ADDENDUM No. 3 TO THE CONTRACT DOCUMENTS

Project: City of Unalaska Light Cargo Dock Expansion

Addendum Issue Date: June 10, 2016

All remaining marine mammals are subject to the “action area and exclusion zone” as shown in the NMFS concurrence letter Figure 3, located in the permit section of the contract documents.

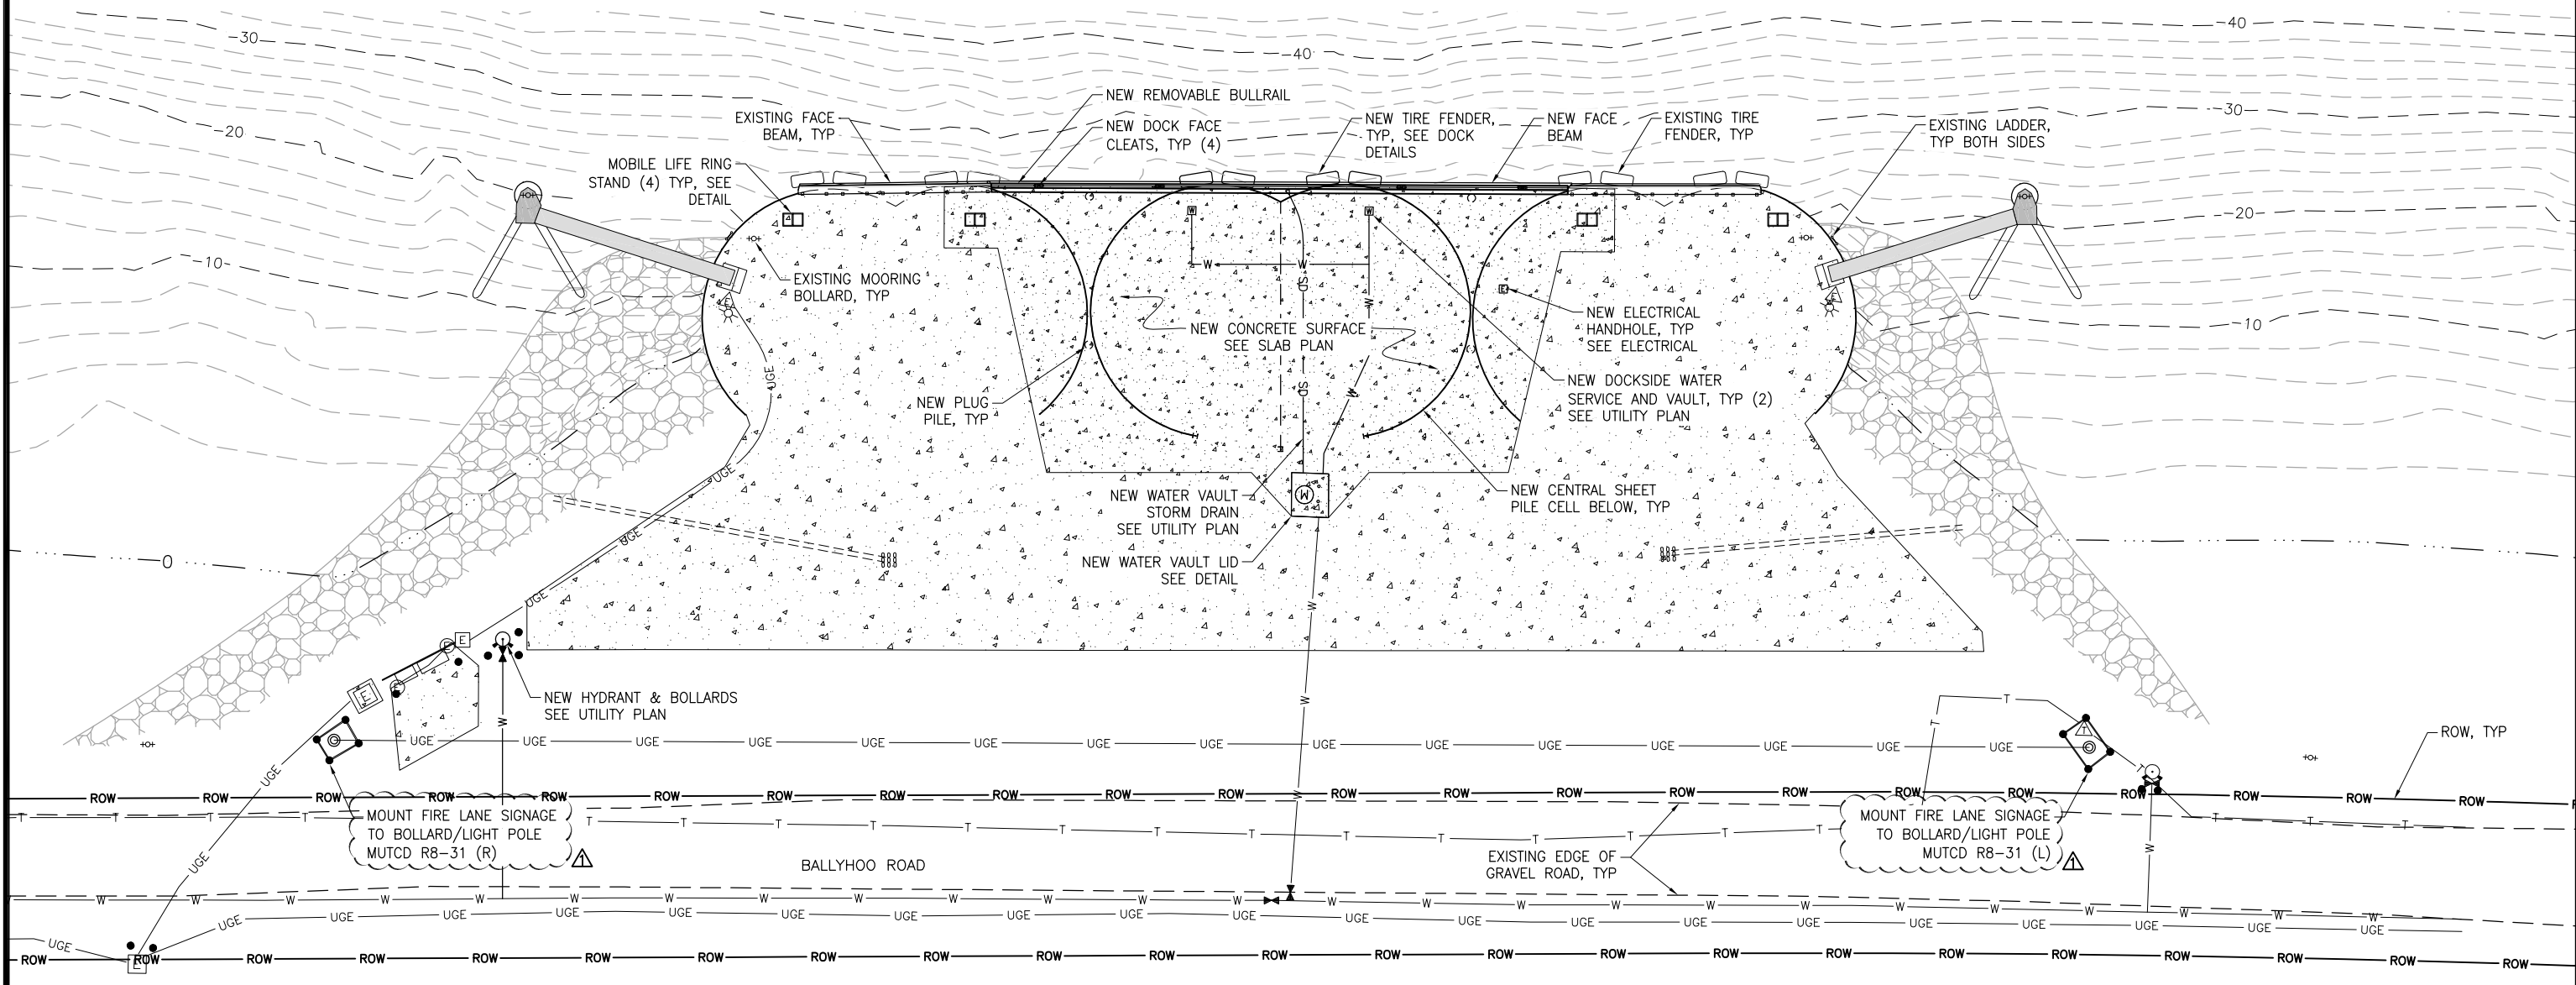
Q1: Can you provide more guidance/clarification on the pile driving shutdown requirements and soft start procedures? I am looking for clarification regarding shutdown radii for protected, threatened and endangered species. In reference to the NMFS letter page 6, a map of the exclusion zone extends from the end of the spit toward the airport. Is this exclusion zone meant to cover all marine mammals? On page 7 under 4.4.1 it states if any marine mammal is present "with the zone" pile driving and removal activities will not begin. Also 4.5 states to continuously scan the exclusion zone to ensure marine mammals do not enter it throughout pile driving activities. Is my interpretation correct that any marine mammal (even non ESA-listed) within the 2,000 meter exclusion zone will prevent pile driving?
